御中		Issue No. / 発行№: PC-0021904	
		Issue date / 発行日: 2022/03/29	
<h2>工程変更連絡書</h2> <h3>Process Change Notice</h3>		ヒロセ電機株式会社 工場 品質管理課 XX Factory, Quality control section, Hirose Electric Co., Ltd.	
		承認 (Approval)	査閲 (Review)
		作成 (Created by)

貴社品番/Product number of your company				弊社品番/Product number by Hirose Refer to Attachment List (Page 2)				弊社品名/Product name by Hirose Refer to Attachment List (Page 2)									
Content of change / 変更内容	変更 1	区分 Type	捺印変更レーザー刻印する Ink engraving changed to laser engraving	理由 Reason				品質安定の為です / Stability of quality									
	変更 2	区分 Type	-	理由 Reason				-									
	変更前 Before the change			変更後 After the change				影響範囲 The scope that will be affected.									
	捺印 Ink engraving			レーザー刻印 Laser engraving				設計変更は伴わない為、製品仕様、性能に変更はございません。 There is no design change, so there is no change on product specifications and performance.									
Execution schedule of the change plan / 変更実施計画	日程 Schedule	4/F	4/M	4/E	5/F	5/M	5/E	6/F	6/M	6/E	7/F	7/M	7/E	8/F	8/M	8/E	9/F
	工程整備 Preparation of process		→														
	標準類の整備 Preparation of standards, etc.			→													
	トライ / Trial					→											
	作業教育 Education on operators								→

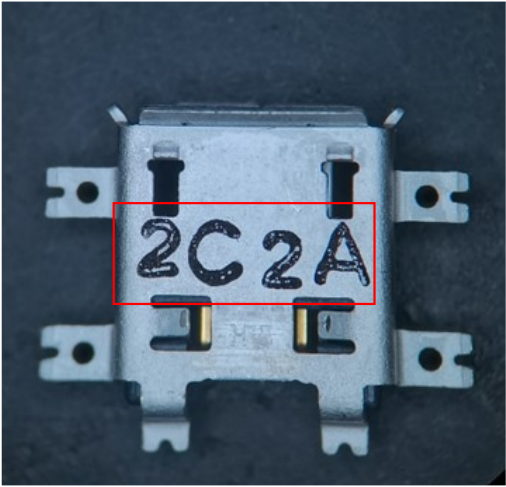
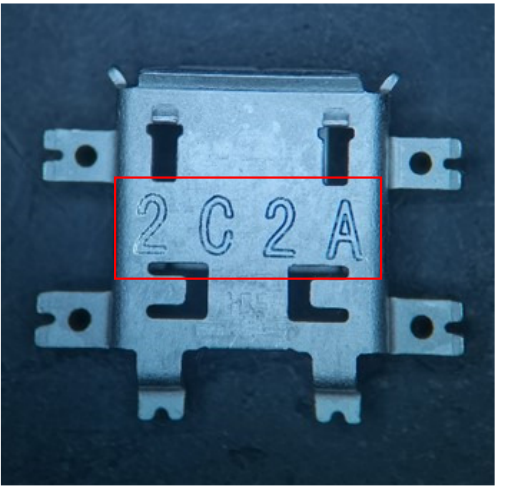
Changed from ZX62M ink engraving to Laser engraving

Item	Before the change: Ink engraving	After the change: Laser engraving
ZX62M-B-5P(30) 242-0024-7-30 representative	 A photograph of a white plastic component with a red rectangular box highlighting the text '2C2A' which has been engraved using ink. The text is dark and slightly irregular.	 A photograph of the same white plastic component with a red rectangular box highlighting the text '2C2A' which has been engraved using a laser. The text is light blue and very clean and precise.
